SAFETY RECALL BULLETIN

SUBJECT:			No: SR-10-003
HVAC CONTROLLER REPLACEMENT — SAFETY RECALL CAMPAIGN			DATE: October, 2010
			MODEL: 2006-08 Endeavor
CIRCULATE TO:	<input type="checkbox"/> GENERAL MANAGER	<input checked="" type="checkbox"/> PARTS MANAGER	<input checked="" type="checkbox"/> TECHNICIAN
<input checked="" type="checkbox"/> SERVICE ADVISOR	<input checked="" type="checkbox"/> SERVICE MANAGER	<input checked="" type="checkbox"/> WARRANTY PROCESSOR	<input type="checkbox"/> SALES MANAGER

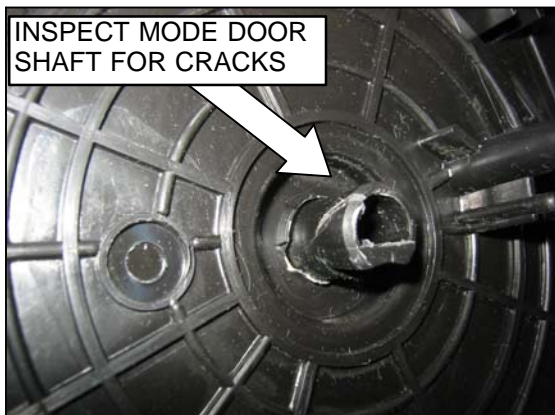
3. Replace the heater controller assembly with the new, improved part listed in the PARTS INFORMATION section of this bulletin. Refer to GROUP 55A in the appropriate service manual for heater controller assembly replacement details.
